FNSB Roads Plan: Public Comment Tracker, June-July 2023 (In response to June 2023 Full Draft Plan)

Comprehensive Roads Plan

348:

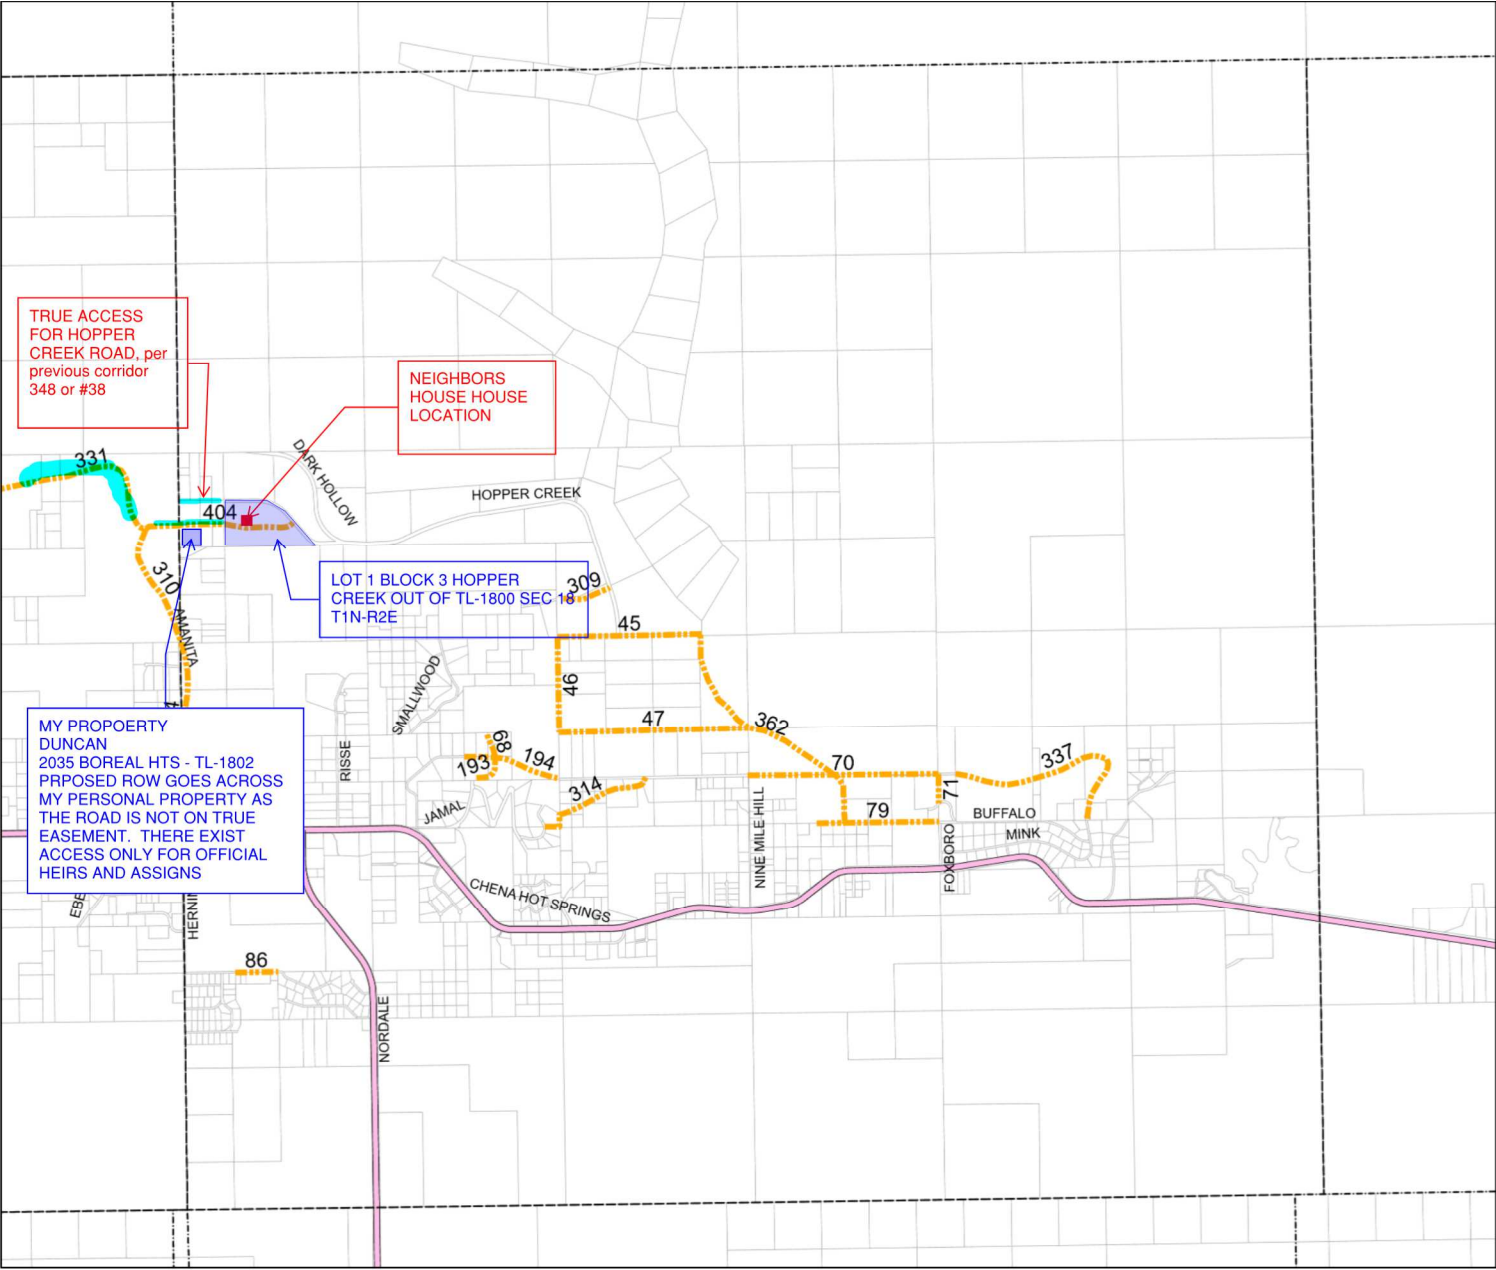
We would like to know the reason why corridor #38 was suggested or what its purpose is.

DATE OF INSPECTION: 9-24-07 ADDRESS: 2035 Boreal Heights Lane SCALE: 1" = 100'

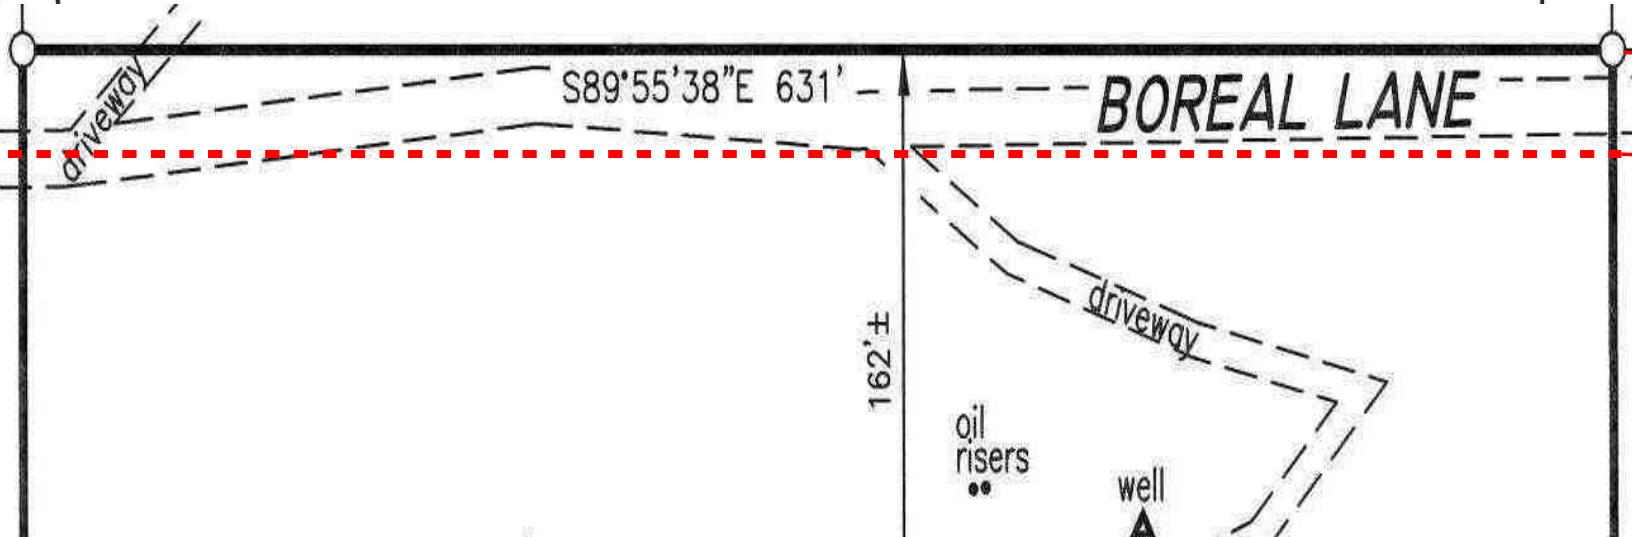
- This suggested ROW 404 has an easement that is on my property 2035 boreal hts. See attached 1,2 and 3 mentioned above. As you can see this proposed ROW affect my property as there is an easement on my property, **and the current road is not on its correct easement – See attachment 3.** It currently crosses a portion of my private property. I would also ask that if this “Road Plan” is to be considered in the future that the road be put back on its true easement and moved further north at the expense of FNSB

Discussion of Corridor 251 in the current draft of the FNSB Comprehensive Roads Plan.

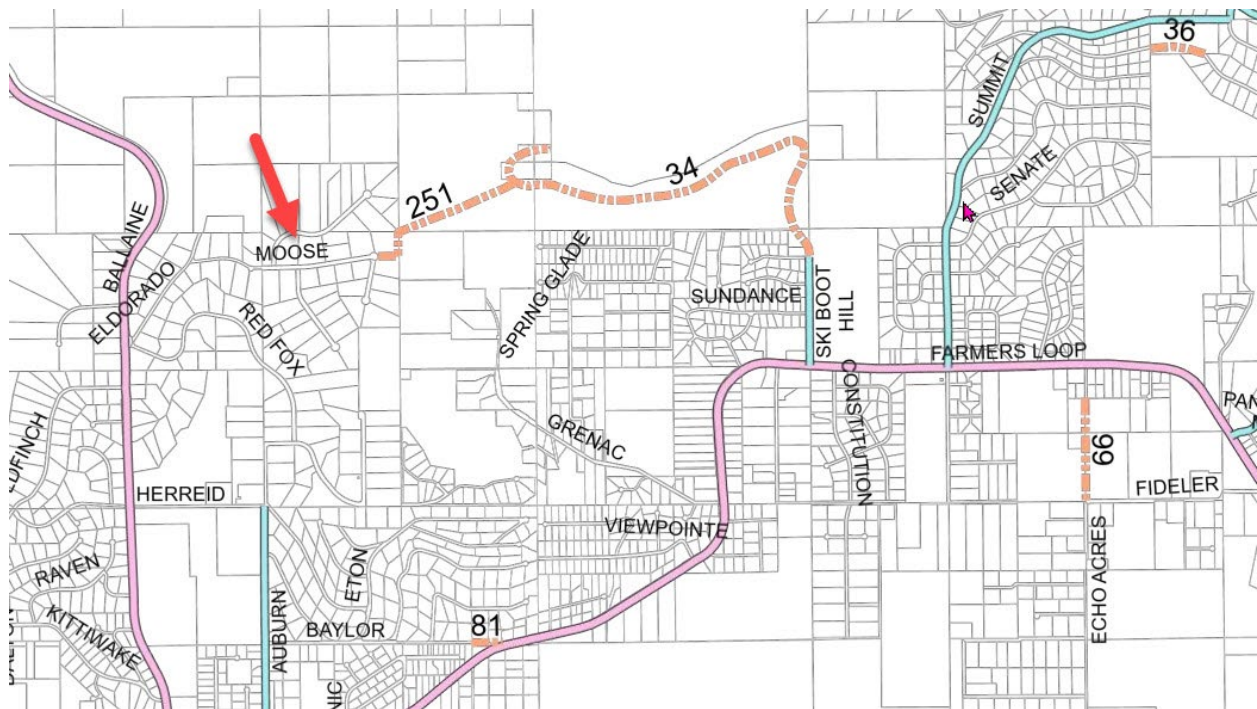
This comment refers to **Corridor 251**. This proposed corridor would effectively extend the current road, Moose Trail, in the Musk Ox subdivision. The proposed corridor will increase traffic on a substandard road and thus increase hazard to residents and others using Moose Trail. I request that Corridor 251 be removed from the Roads Plan.

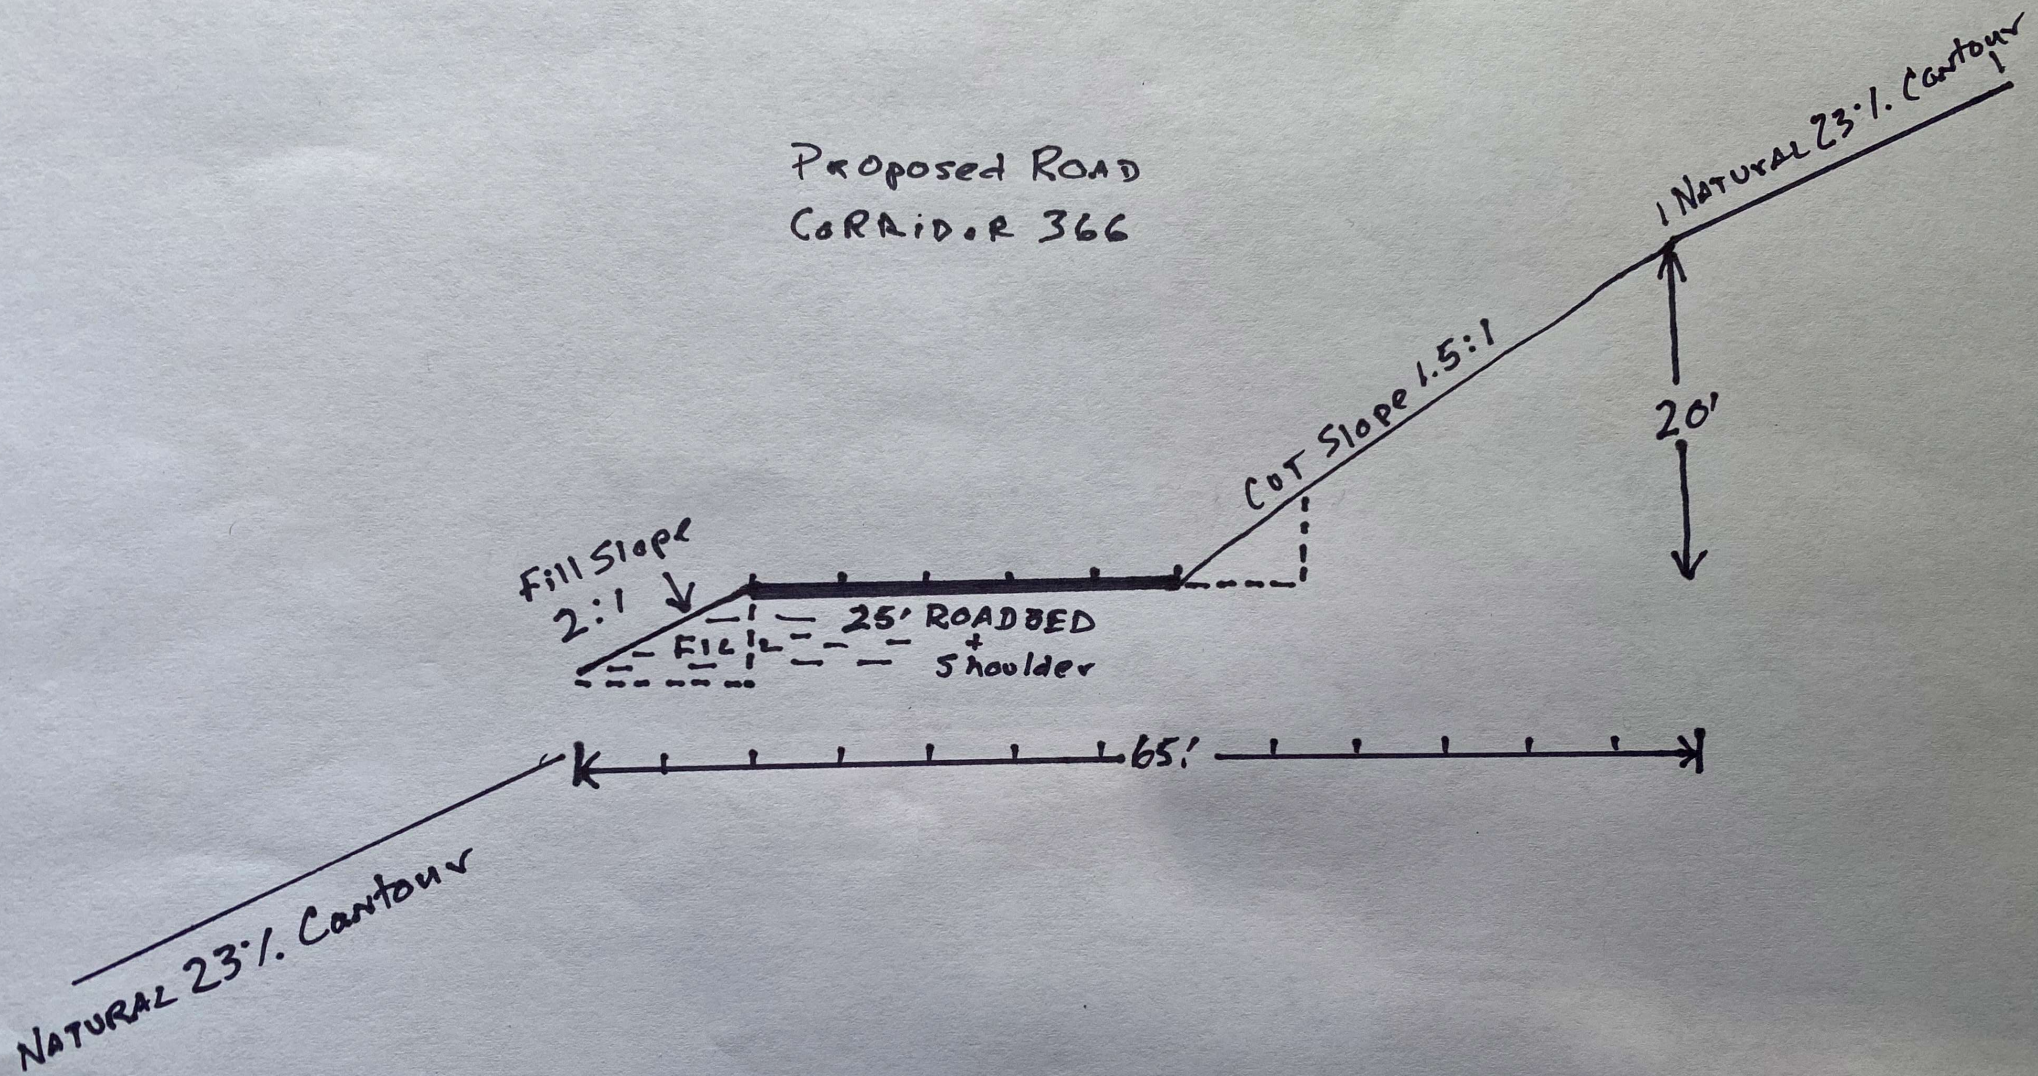
- The proposed corridor 366 has a cross slope natural contour ranging from 14-23% according to the borough's Infracore Model. All state road commission plans that I reviewed classify cross slopes from 14-23% as "very strong slopes" and stated that cross slopes beyond 15% incur significant construction costs. The attached figure displays a reasonable schematic using standard road construction specifications of how a 25-foot 2 lane road with minimal ditching would need to be constructed based on a 23% natural cross slope. The schematic assumes that 40% of the roadbed would be constructed with fill slope (1.5:1 ratio) material and 60% of the roadbed constructed from cut slope materials (2:1 ratio). At cross slopes of 23% the proposed corridor would require a footprint construction width of approximately 65 feet to construct a 20-foot roadbed presumably with uphill and downhill drainage. Note that the uphill cut requirement would be 20 ft above the road level. This construction cannot be accomplished in an economical or safe manner. Extraordinary amounts of fill would need to be removed from the cut slope and the remaining 20-foot-high elevated cut slope would pose a safety concern for traverses on foot above the cut. A safety fence would be required to mitigate this hazard.

We request removal of corridor 366 from the plan which will result in a cost savings to borough taxpayers by refocusing future borough road planning efforts to areas that are practical and of benefit to the majority of affected parties.

366	7/16/23	Email	X	Mark & Kathy	Bertram	We believe the borough's initial assessment of proposed corridor 366 is not thorough, does not include the factors identified above and underestimates the impact of a 14-23% cross slope making proposed corridor 366 non-economical, impractical, and unsafe. During the comment period 20 public comments were received from residents of the Ida Lane and Taroka areas to remove proposed corridor 366 from the borough plan. No other proposed corridor in the plan received this number of comments. There is unquestionably strong local public support to remove proposed corridor 366 from the borough plan. We request removal of corridor 366 from the plan which will result in a cost savings to borough taxpayers by refocusing future borough road planning efforts to areas that are practical and of benefit to the majority of affected parties.	Thank you for your comments. Corridor 366 has been removed from the plan based on public feedback. A Future Study corridor has been added to the unconstructed portion of nearby Becker Ridge to allow for further study of Becker Ridge as an alternative connection to Chena Ridge for this area.

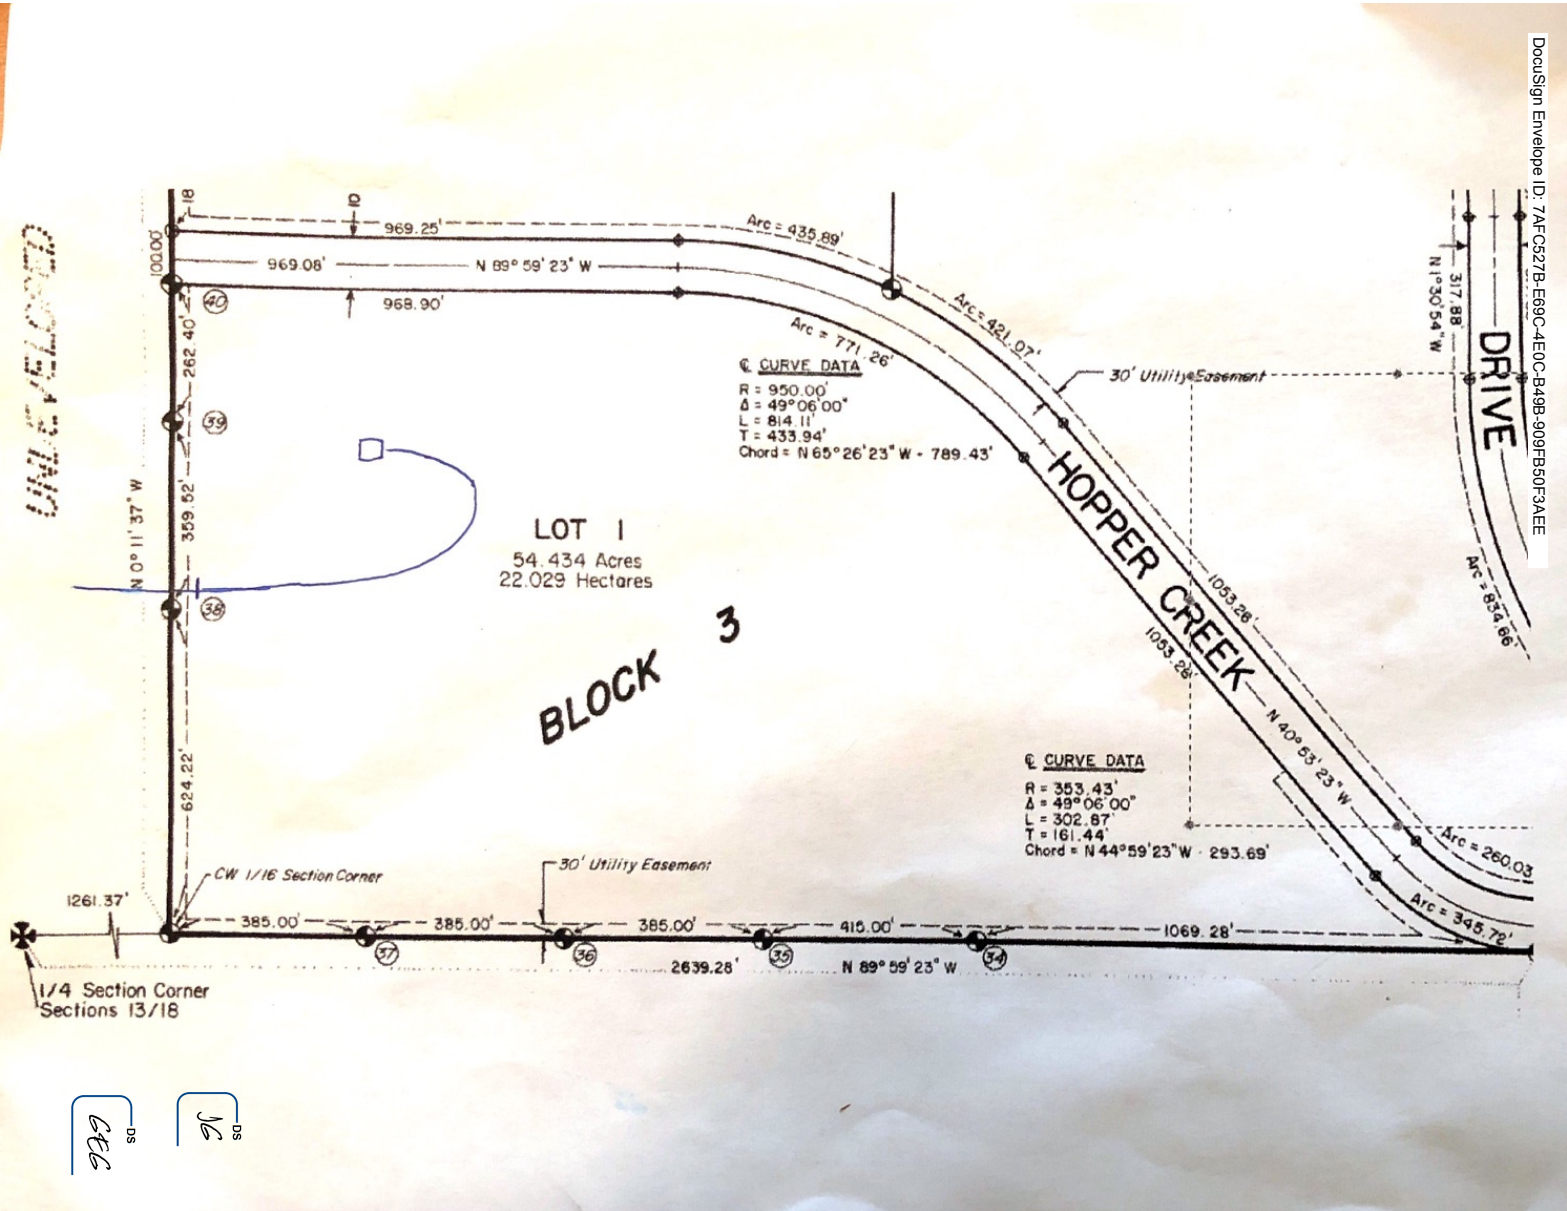
This proposed road that it is showing connecting Boreal Heights to Hopper Creek Drive will not be approved by us since it was proposed going through private property. Boreal Heights ends at the entrance of our property (As seen in the enclosed map in blue) and we have no direct connection from our property to that area of Hopper Creek.

Second We are the owners of Lots 1 & 2 of BLOCK 1 (as well as Lot 1 of BLOCK 3 where Boreal Heights ends) and the ROW to access these areas should be per corridor 348 as the true access between TL 1808 and 1812.

404	6/17/23	Email	X	Juan P.	Grimaldos	We appreciate the opportunity to comment on the road plans. First we would like to support the comments from Mr. Tom Duncan more specifically about plans for roads 404. This proposed road that it is showing connecting Boreal Heights to Hopper Creek Drive will not be approved by us since it was proposed going though private property. Boreal Heights ends at the entrance of our property (As seen in the enclosed map in blue) and we have no direct connection from our property to that area of Hopper Creek. Second We are the owners of Lots 1 & 2 of BLOCK 1 (as well as Lot 1 of BLOCK 3 where Boreal Heights ends) and the ROW to access these areas should be per corridor 348 as the true access between TL 1808 and 1812. These Road Plans are not approve by us since this is a road only accessed and maintain by current owners or tenants of the houses and properties along the way. This is not a public road.	Thank you for your comments. Based on public feedback, the Roads Plan Steering Committee and planning team decided to move proposed corridor 404 back to it's (Corridor 38's) prior location from the 1991 Roads Plan. The corridor will be moved further north to connect the Hopper Creek right-of-way stub with Amanita. With this move, the corridor makes a more logical connection with platted Hopper Creek, avoids existing access easements intended for limited use, and addresses public and landowner concerns.
